Service Information

SI0250

Equipment Affected: CYK and OM Chillers

Field Replacement of 150 lb and 300 lb Sight Glass Kits

FIGURE 1 - SIGHT GLASS KIT, 150 LB (TABLE 1) AND 300 LB (TABLE 3)

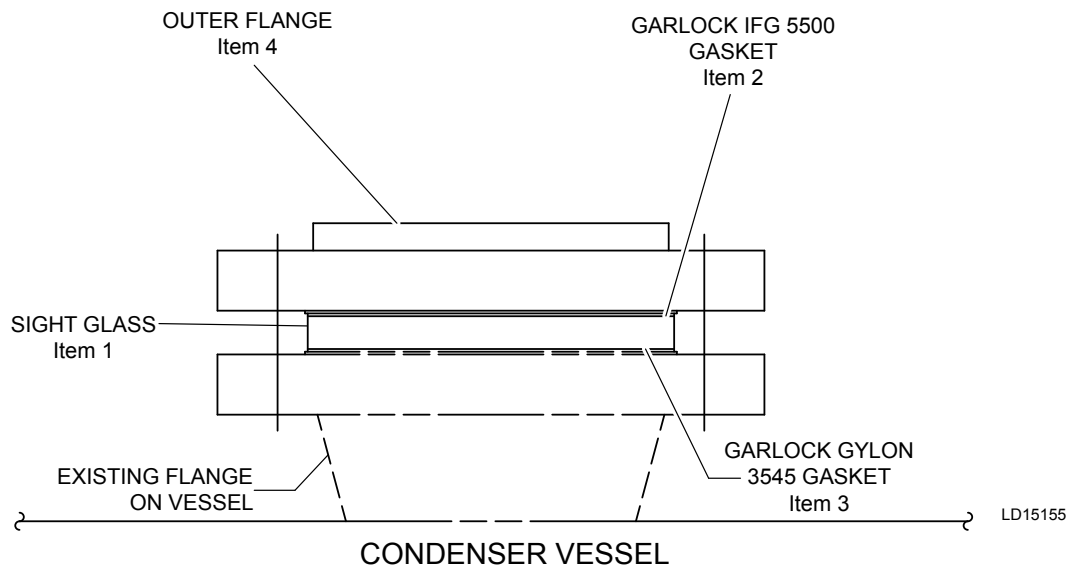
This service information letter revises the torque values and NOTES on the Instruction Bolt Torque drawing 077-10989-000, located in the job specific equipment manual, that has a revision date prior to August 6, 2010 (rev E). Refer to the Revision Record located at the bottom of the drawing for this information.

New gaskets must always be installed on the sight glass if disassembled; however, the sight glass may be reinstalled if it shows no signs of wear, damage or cracks on the sealing surfaces or glass.

4. Install the gaskets and sight glass as shown in Figure 1, cross referencing items and part numbers in Tables 1 or 3.
5. Torque the sight glasses per Table 2 (150 lb.) or Table 4 (300 lb.) using the circular cross-pattern and tightening sequence. Field re-torquing is not required on sight glasses as received installed on the condenser from the factory; however, if a new sight glass and/or gaskets are installed in the field, the bolts must be re-torqued after the first pressure/leak test.

FIGURE 2 - CROSS-PATTERN TIGHTENING SEQUENCE

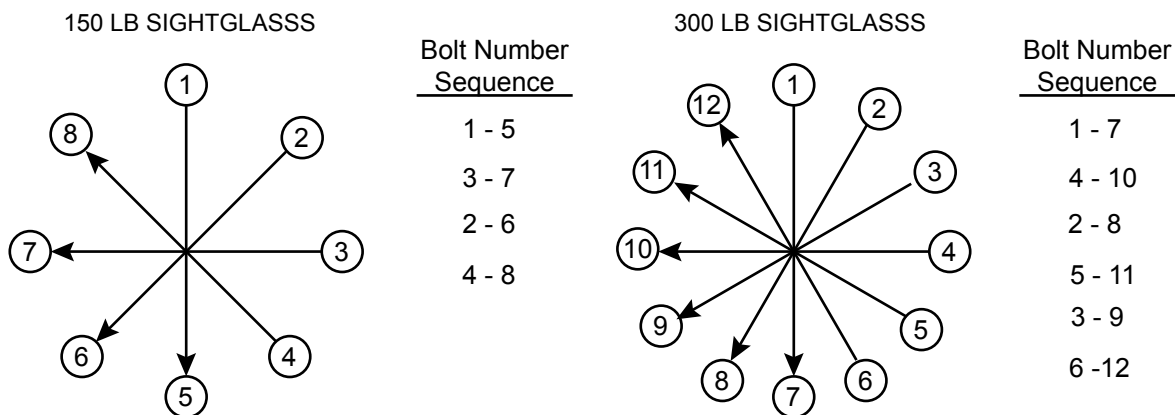
6. A torque wrench must be used for the installation process. Bolt tightening must progress in a crisscross manner (see Figure 2). Torque shall be applied in two steps to avoid uneven gasket compression. The first step is to be 25% of the total value. For example, if the final value is 73 ft-lbs / 99 Newton-meter, the first step would be 18 ft-lbs / 24 Newton-meter. The second step would be 100% of the torque value.
7. Re-torque the bolts after a period of 12 to 24 hours to insure a tight joint and avoid the loosening effects associated with gasket creep.
